Title			
VV5 Preamp - XOno Moving Magnet Phono Preamp			
Size	Number	Revision	3
A2	RSTA0026.3		
Date:	27.02.2012	Sheet of	
File:	C:\User\...MovingMagnetRev3.SchDoc	Drawn By:	Ralph Stens

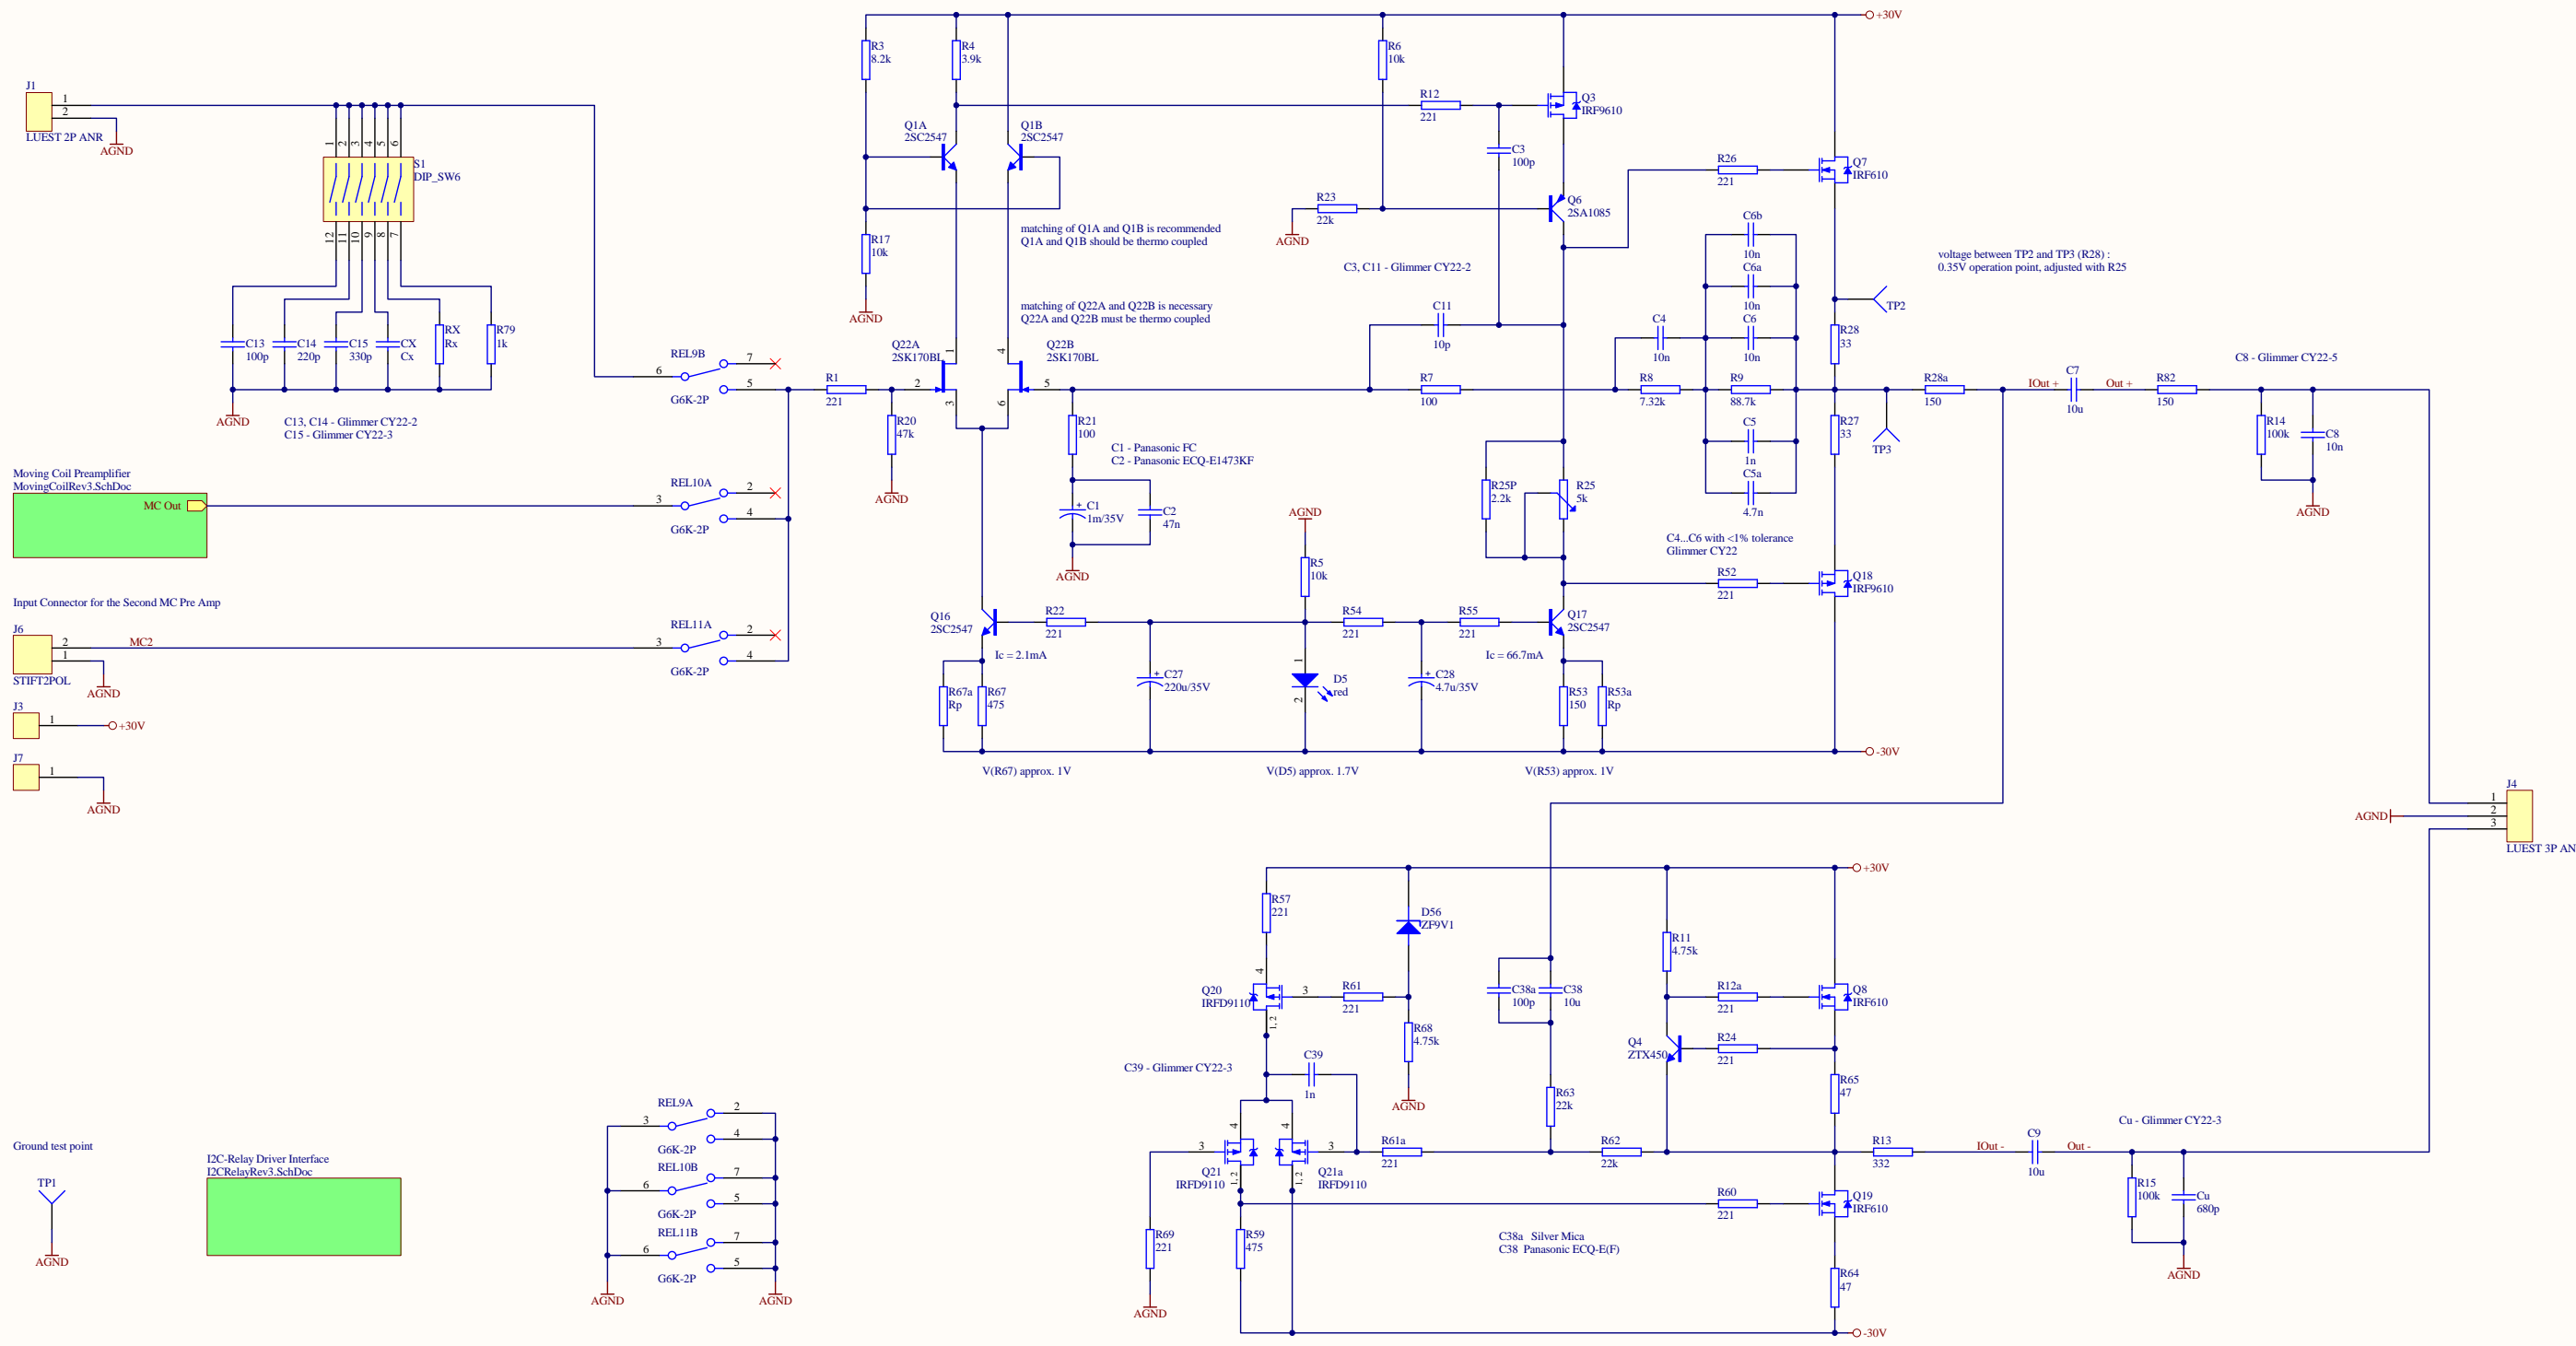
Rev. 3
 BC550C changed to ZTX450 and 2SC2547
 BC560C changed to ZTX550 and 2SA1085
 R53a & R67a included to trim the current sources Q16 and Q17
 C7, C9 - Mundorf Supreme Caps
 C38 - Panasonic ECQ-E1106KF
 include REL9 - REL11 include
 Replacement of LM317/337 with a Voltage Regulator Module
